Development Review Team Memo

RE: PL20250063 Basecamp Phase II 1850 Luna Ln
Development Plan, Conditional Use and Major Variance
Planning Review Submittal #1

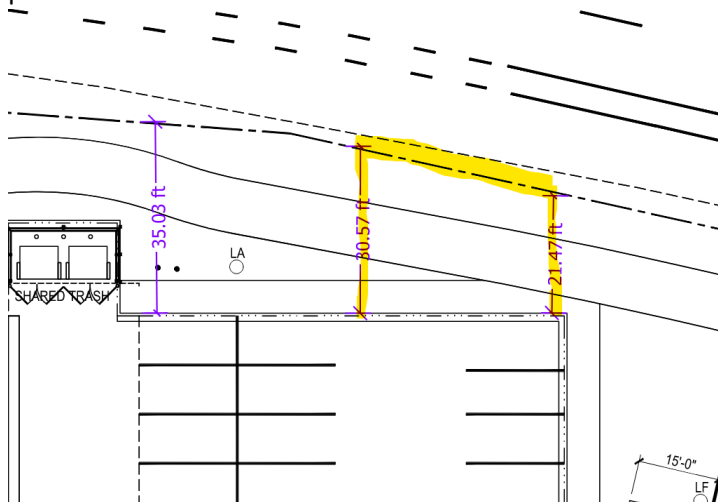
The current proposal relies on a development-wide approach to both parking and snow storage in order to function. Because the viability of the project depends on this integrated approach, what I’m referring to as the “development-wide application thread” must be followed through to the site design, with particular attention to how it addresses key public frontages.

Per 437.C.1.a, development is required to define the edges of and orient access to primary public and private streets, pedestrian circulation, and gathering areas. The Elk River Rd / Lincoln Ave intersection is one of the most significant intersections west of downtown, yet the proposal orients the amenity space—not the building—toward this important corner, with no clear access or frontage emphasis.

This site was previously approved with a commercial component at the Elk River/Lincoln corner—an opportunity that would be precluded by the current layout. While this is not necessarily to suggest that staff is unsupportive of the proposed Multiple-Family and Workforce Unit uses, it’s important to note that the current configuration doesn’t place either a commercial or residential use at this major intersection. As a result, the corner appears deactivated—an outcome that seems misaligned with the CS zone district purpose and the Future Land Use Map Commercial Activity Node designation, both of which call for a higher intensity of development.

In addition, the proposal requires a Conditional Use for the surface parking lot on Lot 3. Approval criterion 707.C.3 requires that negative impacts be mitigated. Multiple-Family Residential Design Standards purpose statement 437.A.3 helps identify one such impact, directing that parking areas should not become the dominant use of common space in multiple-family developments. The current design, which places surface parking at the Elk River Rd. frontage, may not align with this guidance.

In summary, if the project requires a site-wide solution to parking and snow storage, it should also demonstrate a site-wide approach to design—particularly under the lens of the standards in Section 437. Staff encourages the applicant to re-evaluate the site plan to:

- Reflect a stronger building relationship with Elk River Rd and Lincoln Ave—perhaps by swapping the building and open space/parking locations and including a ground-floor commercial use;
- Enhance and preserve long-term activation and vitality at this key intersection; and
- Ensure the overall site layout supports a functional, integrated, and policy-consistent development pattern.

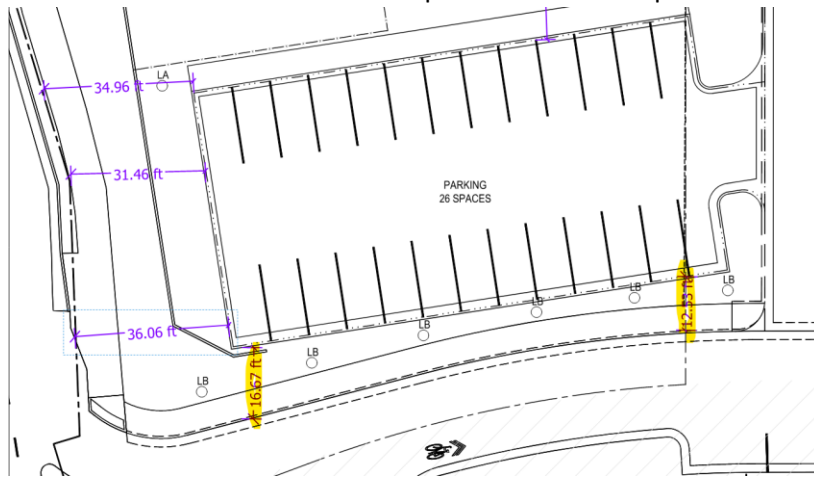
6. It appears a portion of the Lot 2 parking lot encroaches into the required 30' front setback for parking lot placement. Per Section 801.B.1.a.ii, this setback must be measured from the private

street easement. Please revise the plan to ensure compliance.

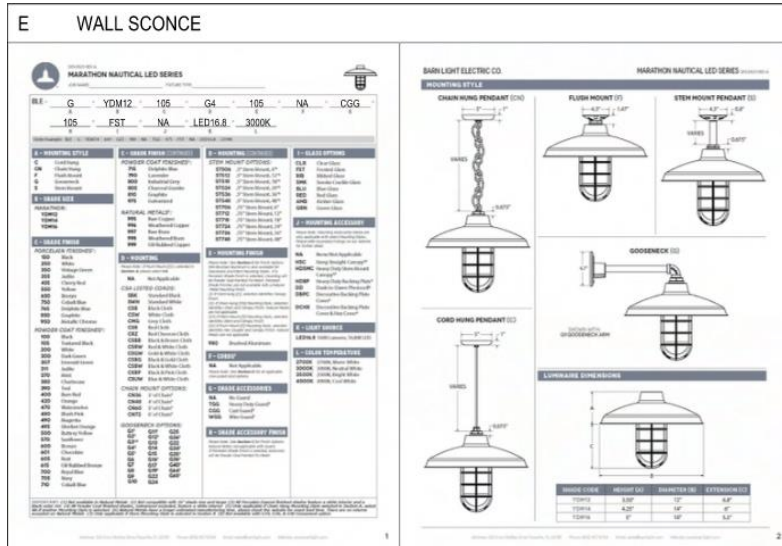
18. The landscape plan incorrectly states that Parking Lot Setback Landscaping is “N/A,” being covered by Frontage Landscaping. Per Section 402.D.2.c and Figure 402-2, when frontage landscaping areas and parking lot setback landscaping areas overlap, the parking lot setback landscaping standards apply. Please revise the plans accordingly to demonstrate compliance with these minimum standards.
19. It does not appear Parking Lot Setback Landscaping has been applied.
20. Interior parking lot landscaping is shown in some areas where parking lot setback landscaping is required instead. These areas need attention to ensure the correct standards are being applied in the appropriate locations. Additionally, please confirm that both parking lots meet the minimum interior landscaping area square footage requirements per Table 402-4.

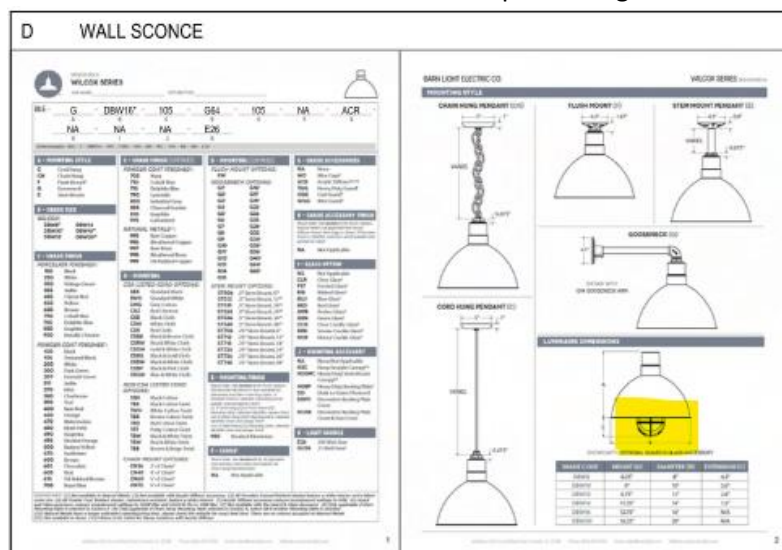
22. The Fixture E Wall Sconce light source is not fully shielded.

23. Fixture D Wall Sconce seems to have an option of light source that is not fully shielded.

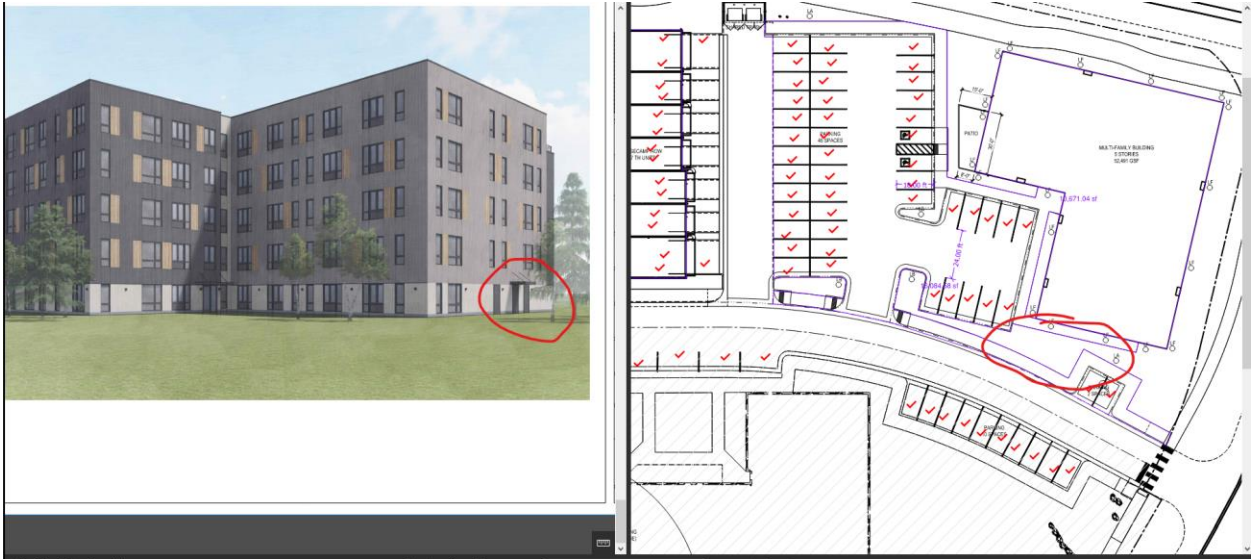
29. The current snow storage approach appears to rely on the development-wide application thread mentioned, which is not explicitly permitted in the CS zone without a variance. To proceed with this approach, the applicant should include a variance request to Section 409.D.1 in the narrative. Section 409.D.3 requires that off-site or shared snow storage be permitted only with an approved snow hauling plan that specifies receiving locations and haul frequency. In the variance narrative, please provide a snow management plan that includes details on long-term maintenance, snow hauling (if applicable), and access arrangements such as easements or plat notes to ensure long-term functionality.

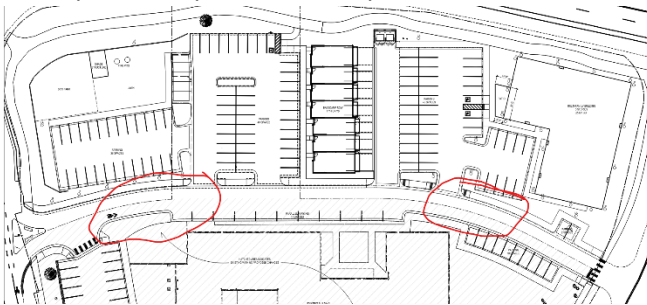
32. The internal sidewalk system is required to provide access to transit facilities, public gathering locations, and major site amenities. It appears that a sidewalk connection is missing from the entrance on the west side of the multifamily building (see markup). Please revise the plan to include a direct pedestrian connection from this entrance to the Big Bend Drive sidewalk in

order to meet this standard.

33. What paths are pedestrians expected to take to cross Big Bend Dr?

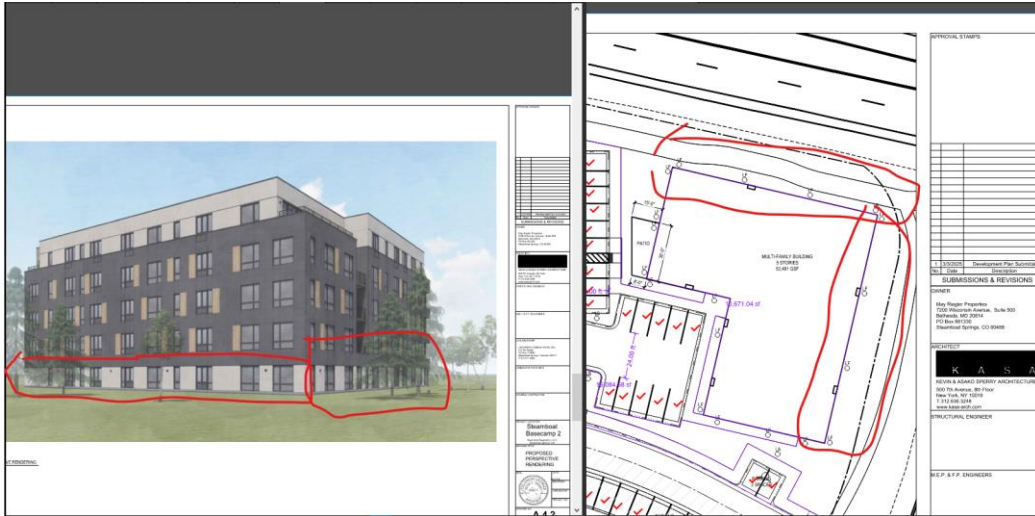
35. Per Section 437.D.1, buildings shall prioritize the orientation of primary pedestrian entries toward predominant public and private streets, pedestrian circulation routes, and gathering areas. Based on the current site and elevation plans, it does not appear that the multifamily building includes any pedestrian access or entries oriented toward Shield Dr or Lincoln Ave. Please revise the design to provide a clear pedestrian connection or access point on these

frontages or clarify how the current layout meets the intent of this standard.

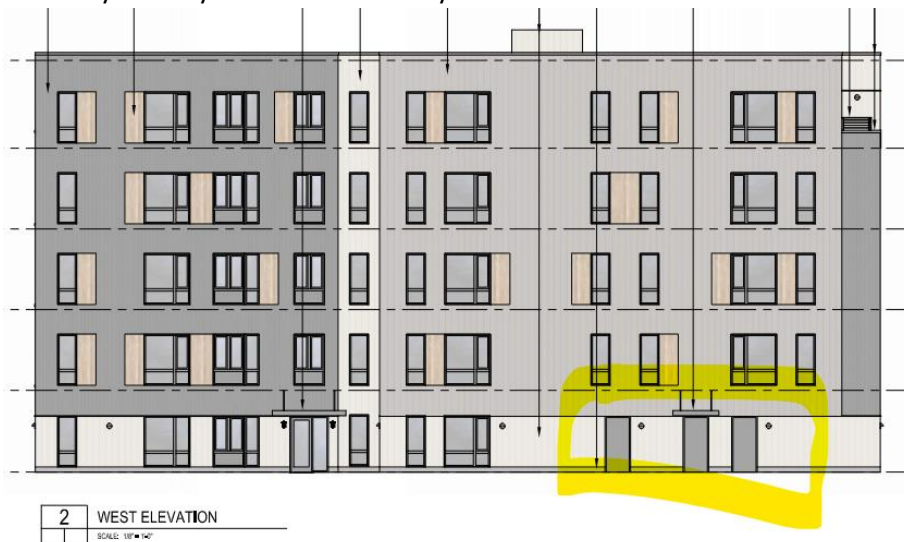
36. The primary entrance on the west elevation appears visually similar to the adjacent utility room door. While the awning provides some distinction, additional architectural emphasis is needed to clearly identify this as a main entry.
